Your Ref
APP/16/00921

Our Ref
PLAN-015653

Proposal: Demolition of the single storey shop, two-storey office building and associated outbuildings. Erection of 4No. houses (3x 3No. bedrooms and 1x 2No. bedrooms) fronting onto Queen Street and associated parking and erection of 2No. detached dwellings (4No. bedrooms) fronting onto to the Mill Pond with associated parking and access from Queen Street.
Site: Dolphin Quay, Queen Street, Emsworth, PO10 7BU.
APP/16/00921

Southern Water MapGuide Browser

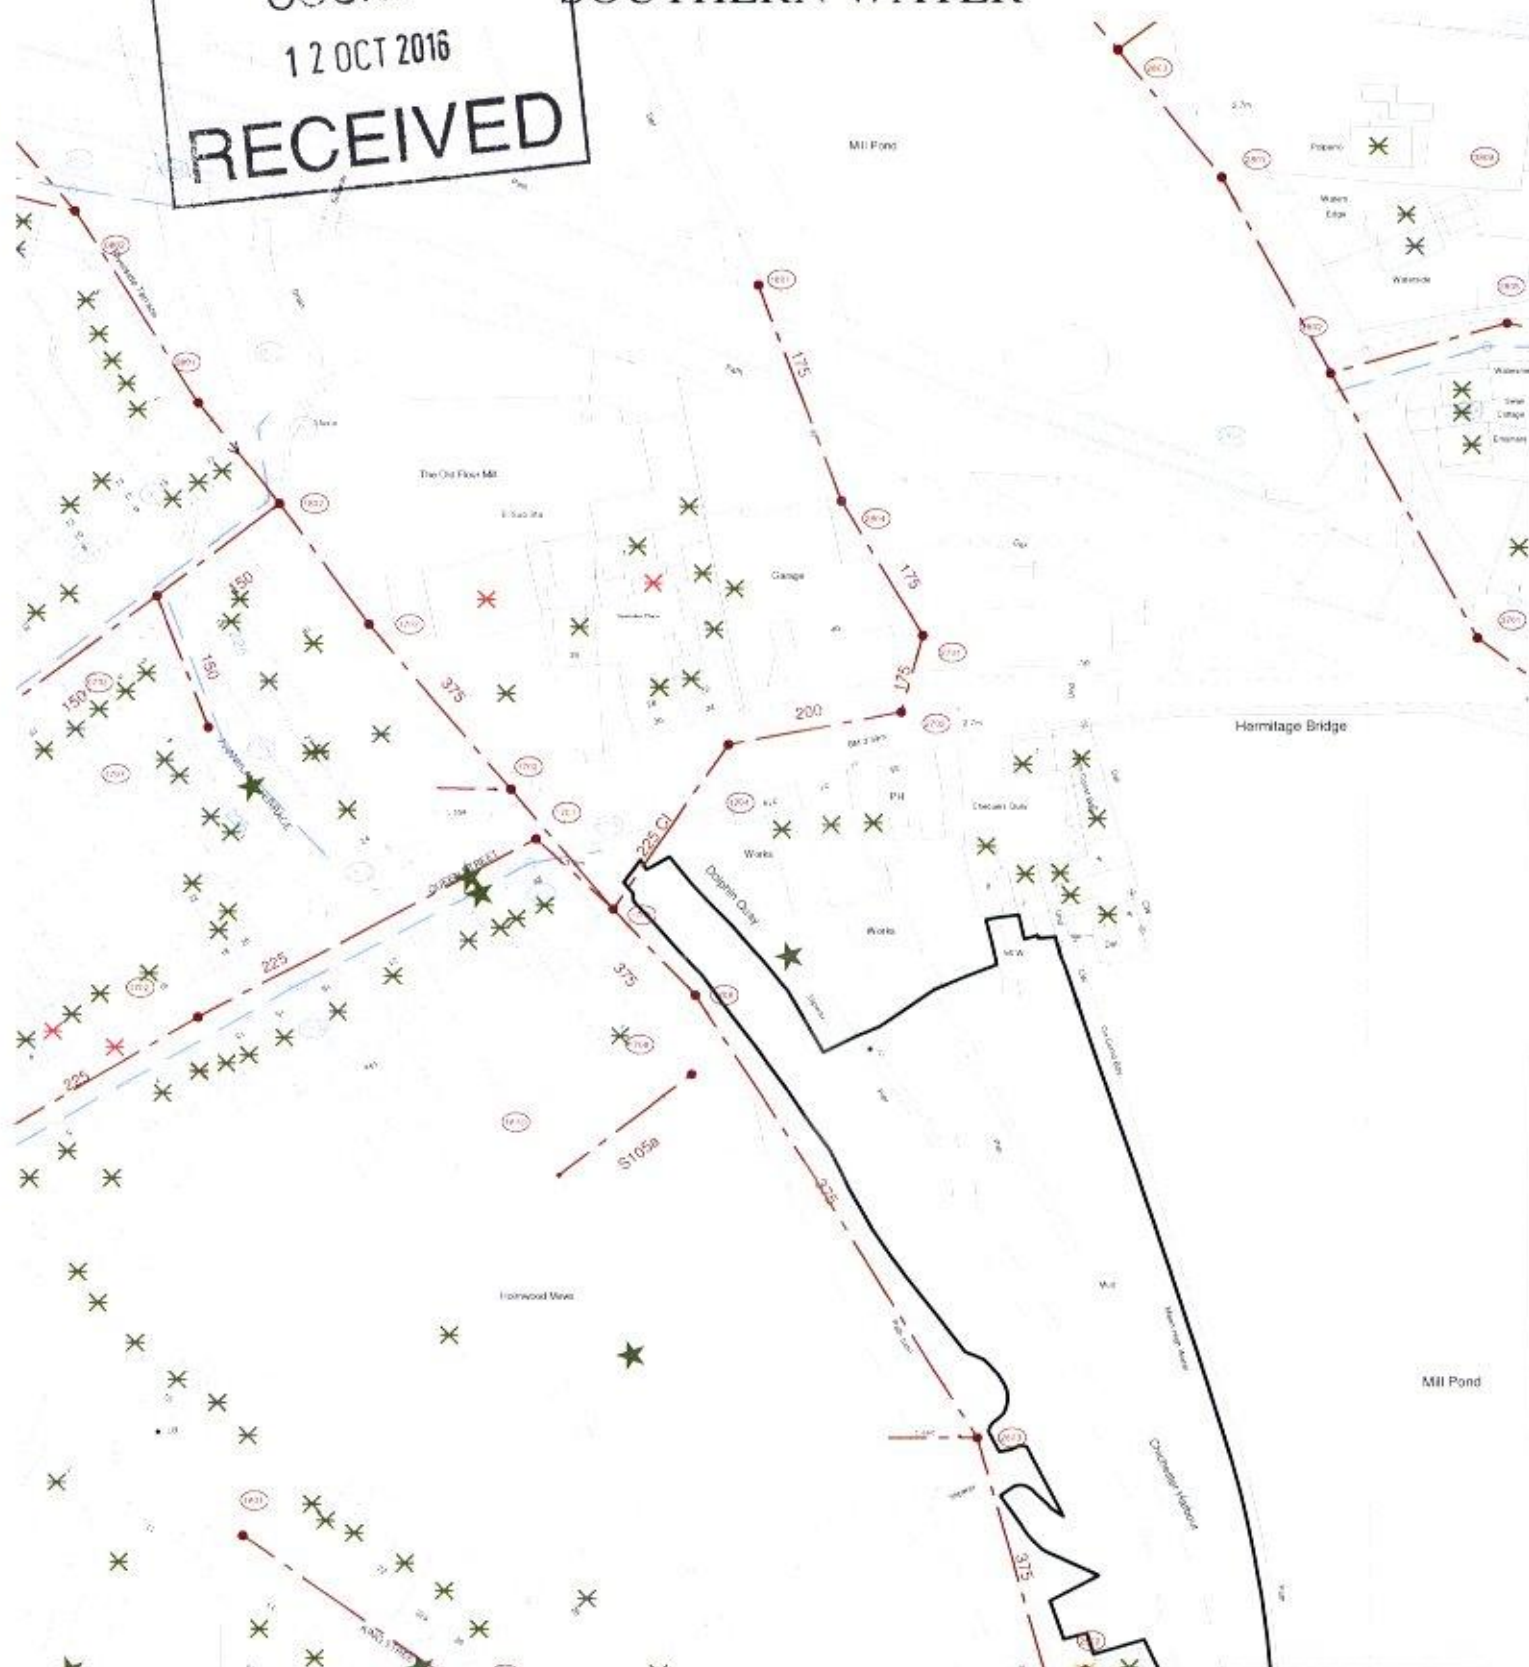
Please find attached a plan of the sewer records showing the approximate position of a public sewer within the site. The exact position of the public sewers must be determined on site by the applicant before the layout of the proposed development is finalised.

- No development or new tree planting should be located within 3 metres either side of the centreline of the public sewer and all existing infrastructure should be protected during the course of construction works.
- No new soakaways should be located within 5 metres of a public sewer.
